UHL BARN AND CABINS

40343 COUNTY RD 68, STEAMBOAT SPRINGS, CO 80487

ISSU	ES/REVISIONS	
NO.	ISSUE/REVISION-NAME	DATE
0.0	PERMIT SET	5/24/23
1.0	PERMIT SET COUNTY COMMENTS	7/23/23

COVER SHEET

BARN AND CABINS DETAILS

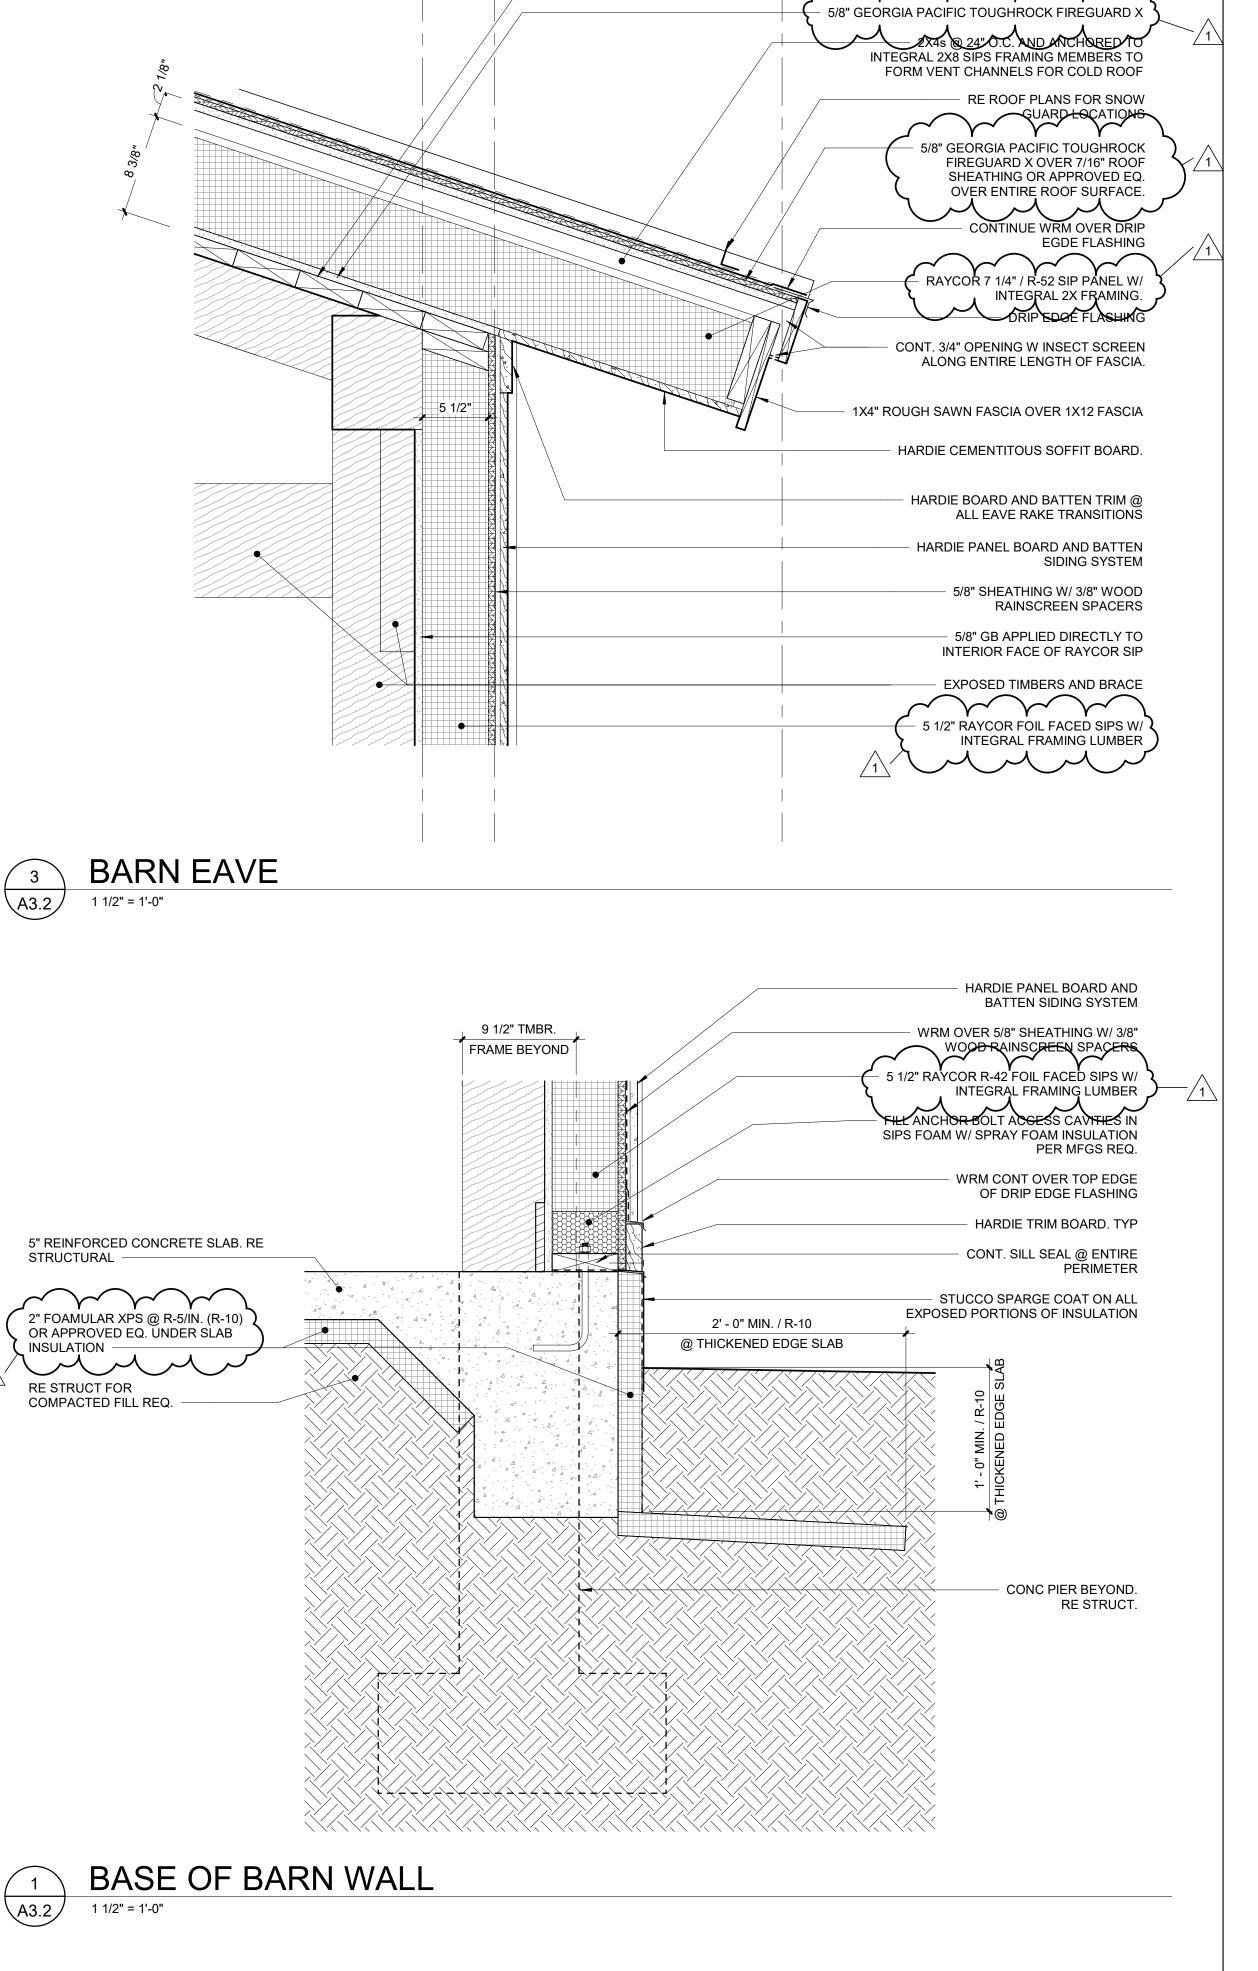
All windows must have a U-factor of .30 or less, please change this on window schedule on sheet A4.0
